Planning and Zoning Board Agenda August 11, 2020

- C. Site Plan – Burger King (16130 NW US Highway 441): A request by Robin Kendall of Quality Dining, Inc., applicant and agent, for T&H Property Group, LLC, property owner, for consideration of a Site Plan to construct a ±3,349 square foot quick service restaurant with associated parking, stormwater, landscaping, and site improvements on a ±1.19 acre subject property. Tax Parcel Number 03061-004-001 (Quasi-Judicial Hearing).

PREPARED BY: Justin Tabor, AICP, Principal Planner

SCALE: NTS	DATE: 12.20.19
CAD FILE: C09-DTLS	
JOB NUMBER: ALACHUA COUNTY	
SHEET C09

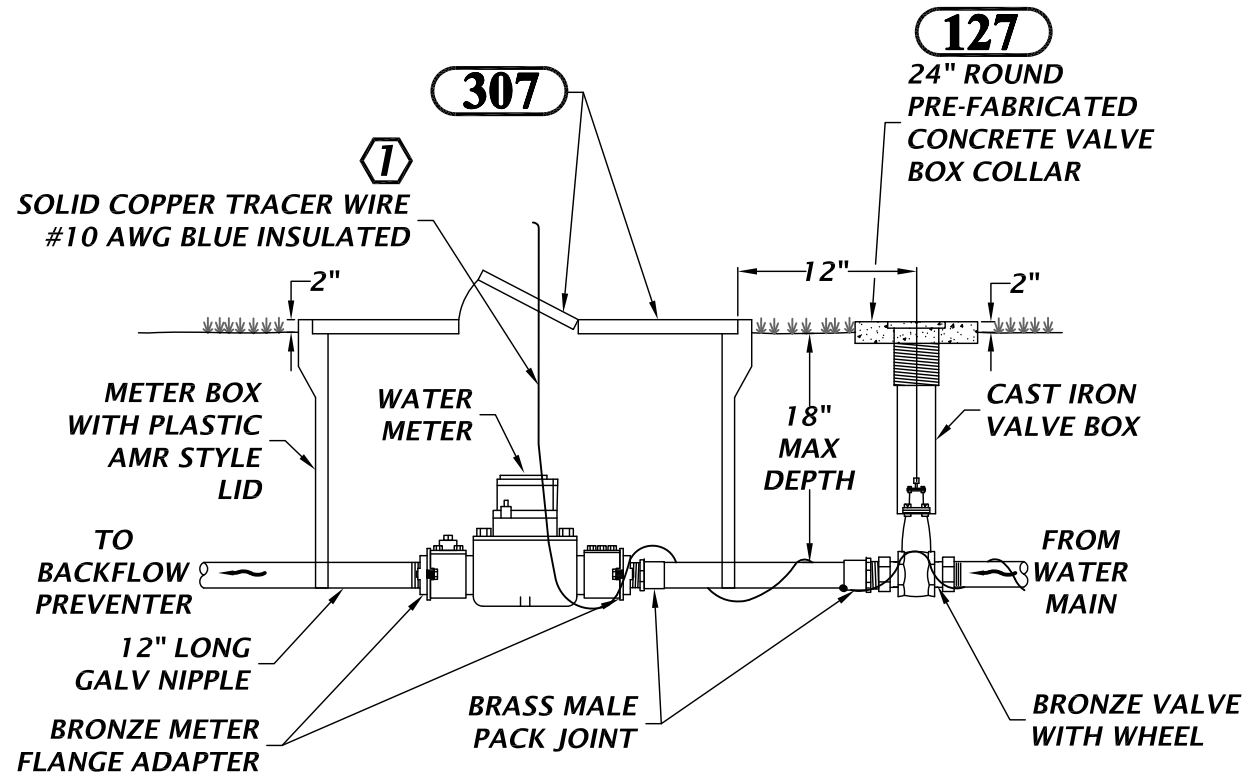
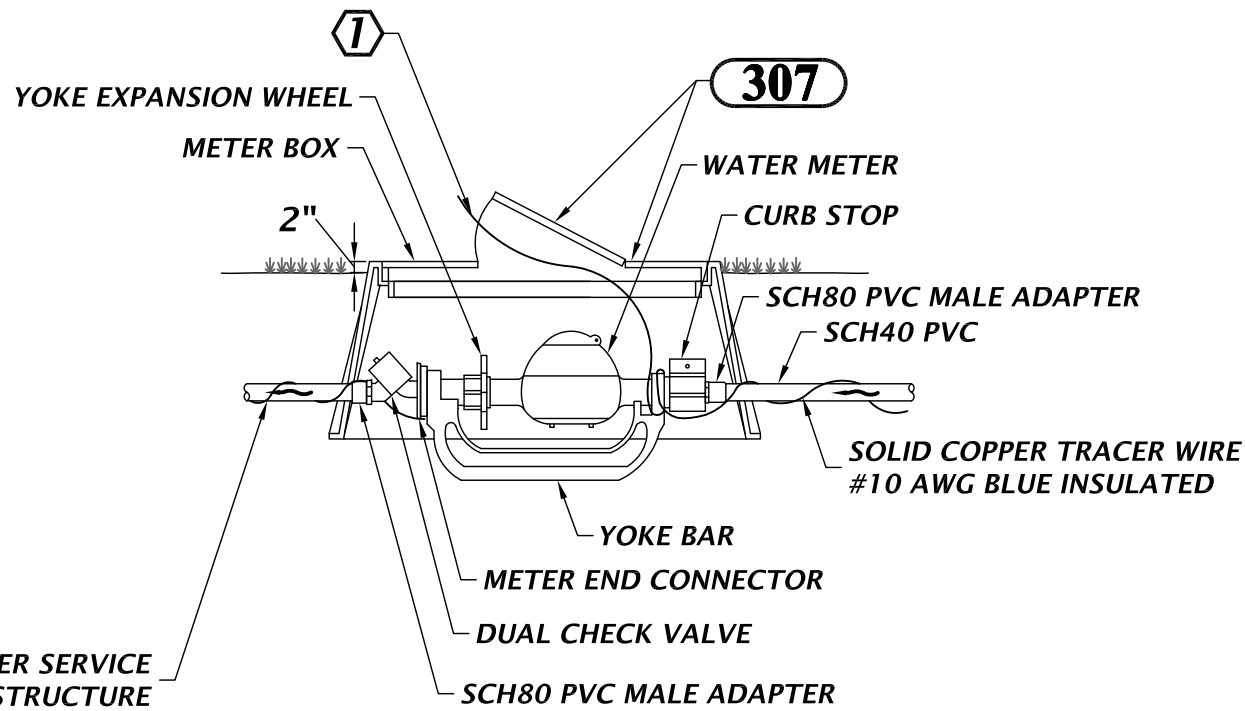
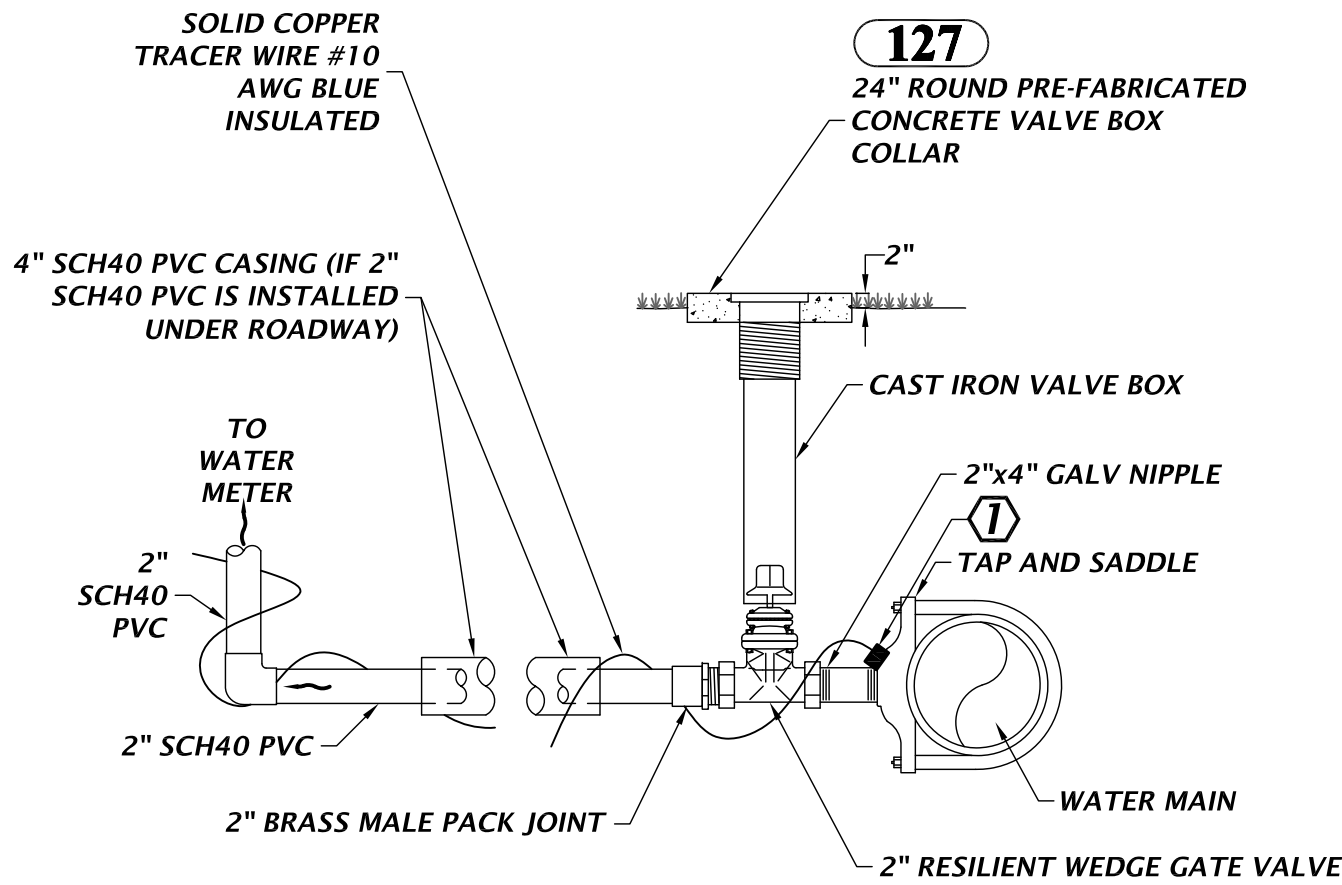
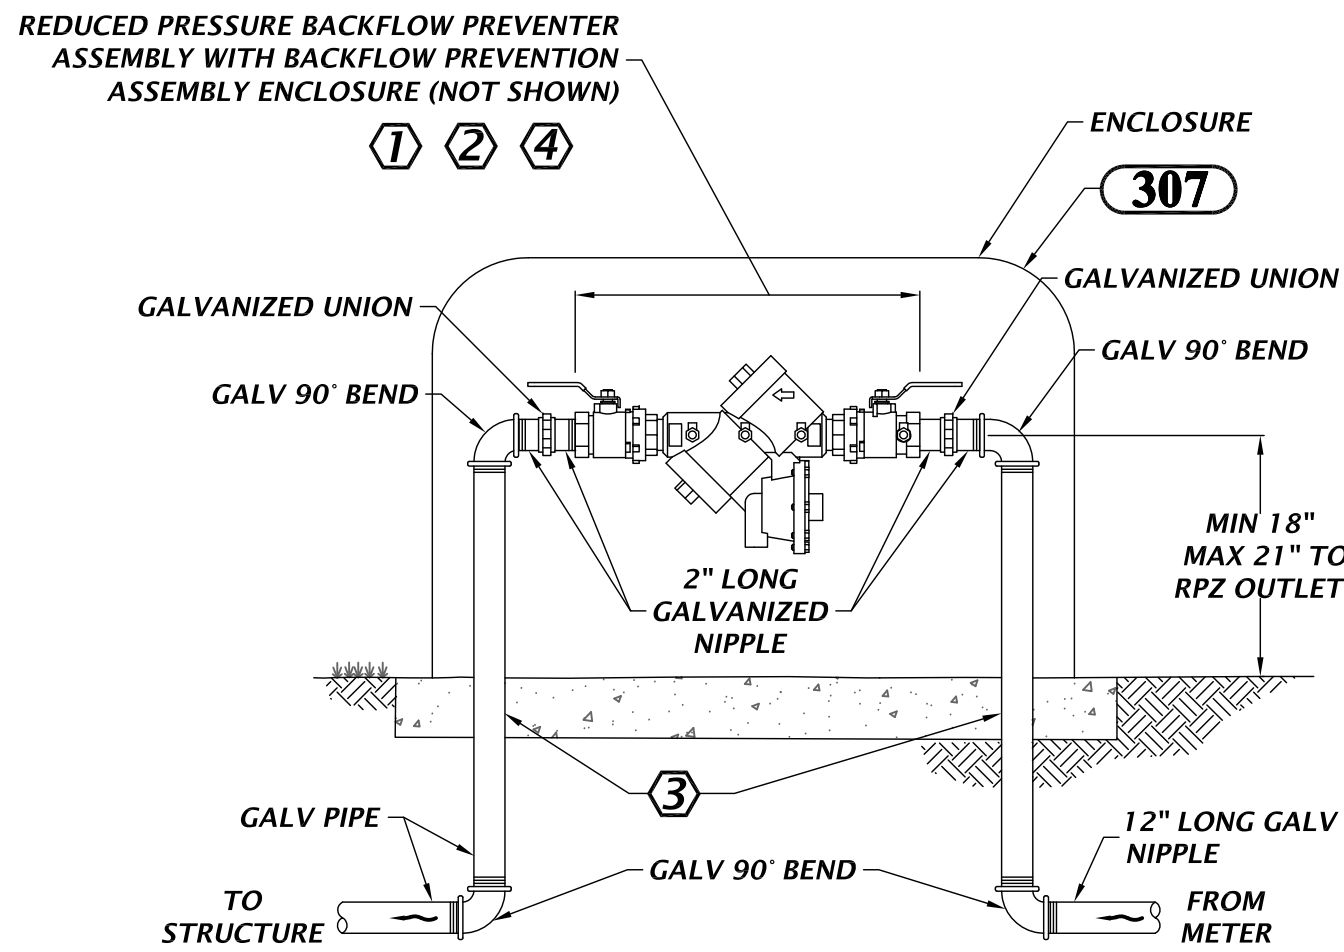
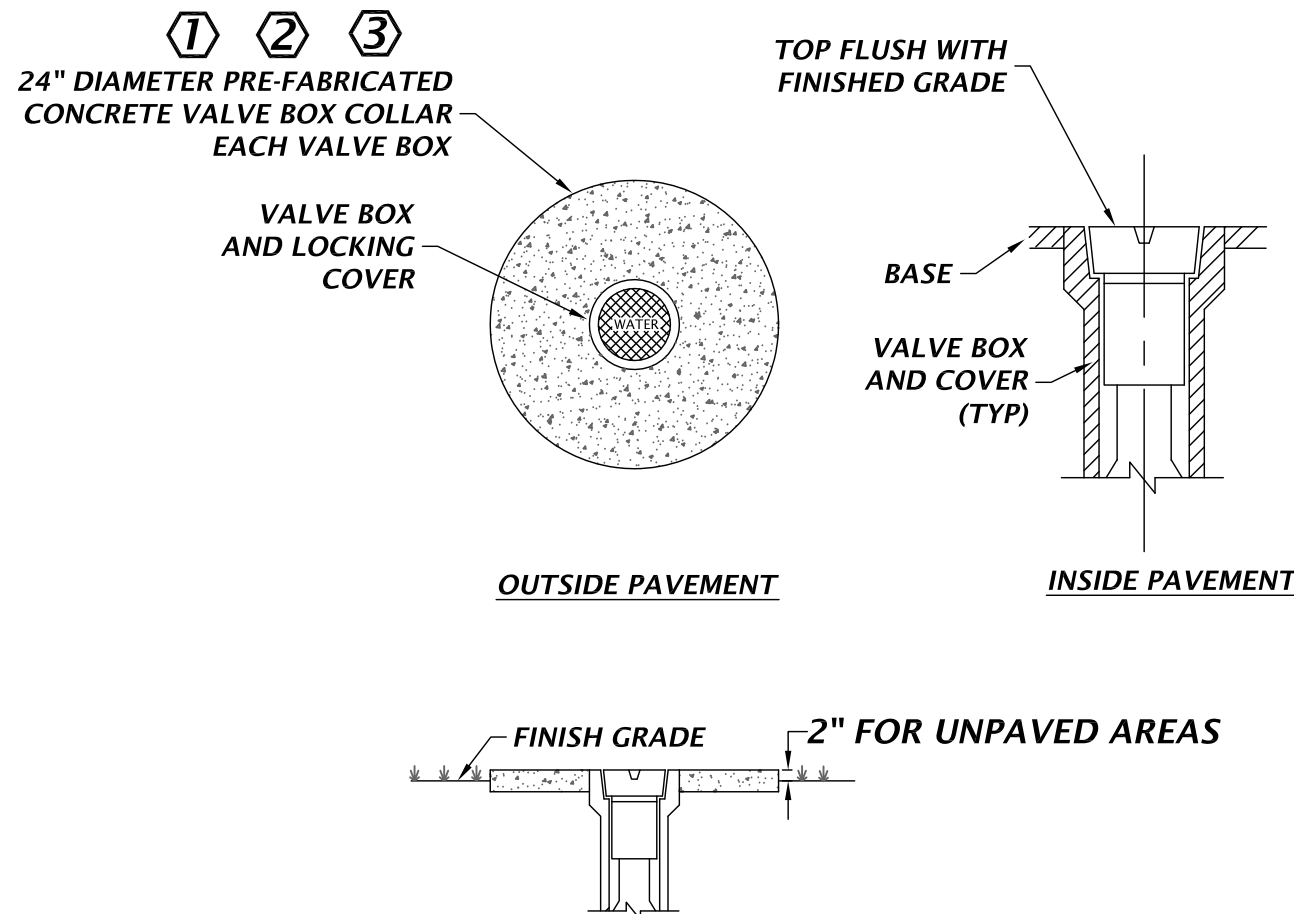
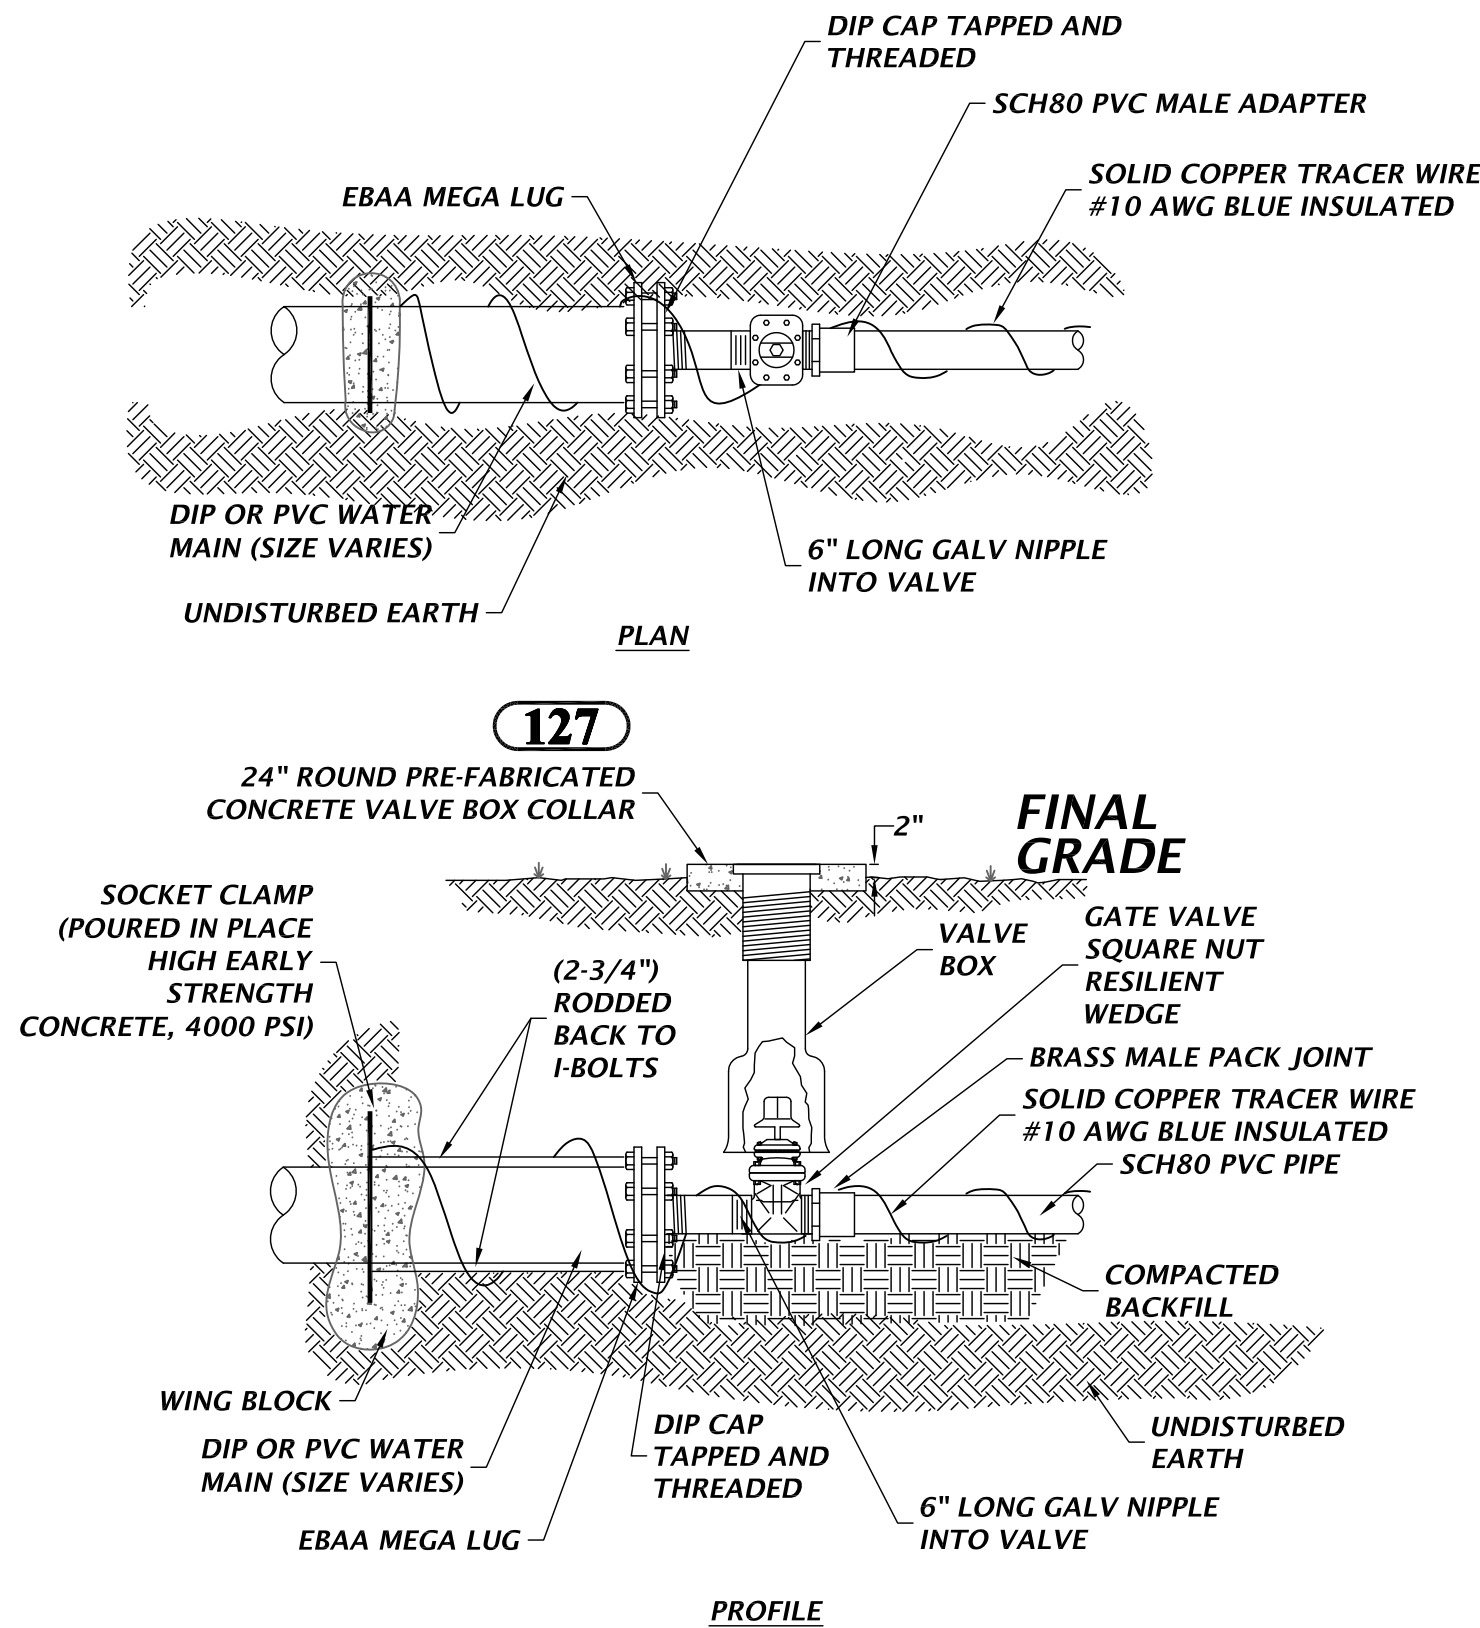
12.	Comment on Jan 12th Submittal Sheet C09 shows Civil Details, which are based on CoA Standard Details, 2017 Version. Please replace with the updated 2020 standard details, as follows: - Partly because the updated 2020 standard details cross-reference other sheets, the required number of details has increased from 4 to 6. These 6 detail sheets are attached in PDF format. - All CoA standard details are also attached in AutoCad format, version 2014. The Engineer may prefer to use details in AutoCad, which could edited so just the details required for the project would become part of the Contract Documents.
END OF COMMENTS

Please add Detail 307 to the Construction Documents. This (painting) detail is cross-referenced by several other details.

Response: The detail has been added to sheet C09.
